Document Description: CSB-SPOT LXI_LED LCD INSTALL	Document Number: 80021534 Version: B

Customer Service Bulletin

Product:	SPOT LXi 4500 Vital Signs	Date:	2016-06-07
Subject:	720480 / DISPLAY,LCD,320X240,LED,MONO,3.3V,5.7" Installation		
HW Version(s) Affected:	SPOT LXi 4500 / All models	SW Version(s) Affected:	N/A
Serial Numbers Affected:	N/A	Lot or Date Code Affected:	N/A
Classification:	As Needed		
Distribution:	<input checked="" type="checkbox"/> Customer Care <input type="checkbox"/> Product Service <input type="checkbox"/> Field Service <input checked="" type="checkbox"/> ASPs <input checked="" type="checkbox"/> Distributors <input checked="" type="checkbox"/> Customers <input type="checkbox"/> Company Confidential		
Training Required:	<input type="checkbox"/> Yes <input checked="" type="checkbox"/> No

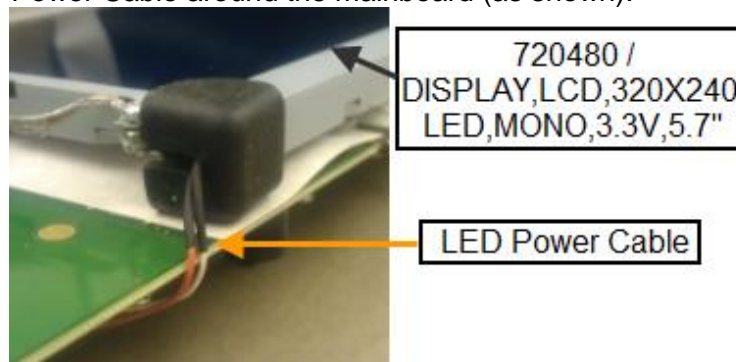
Route the LED Power Cable around the mainboard (as shown):

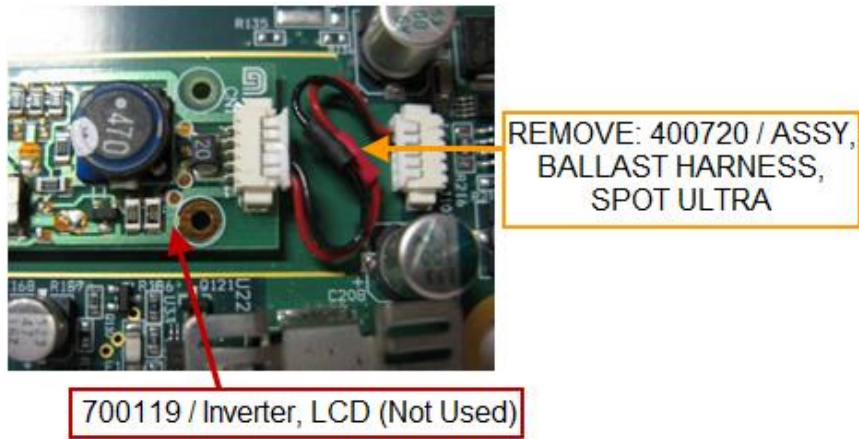
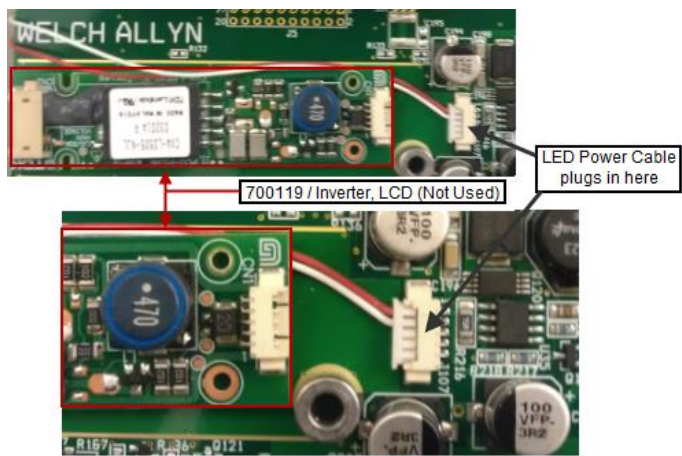
When replacing a CCFL display (703354) with an LED LCD (720480), remove the Ballast Harness assembly (p/n: 400720) from connector J107 and from the inverter board.

By-pass the inverter board with the LED Power Cable and plug it directly into connector J107 (as shown).

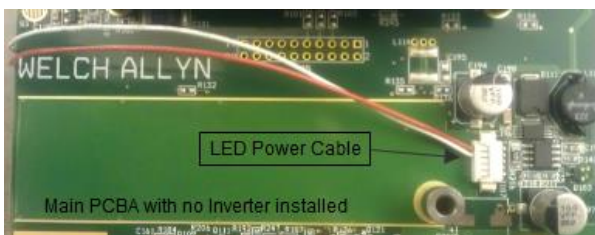
When replacing the LCD in a device that was manufactured after June 2014, there will be no inverter board installed. The LED Power Cable will plug directly into connector J107 (as shown).
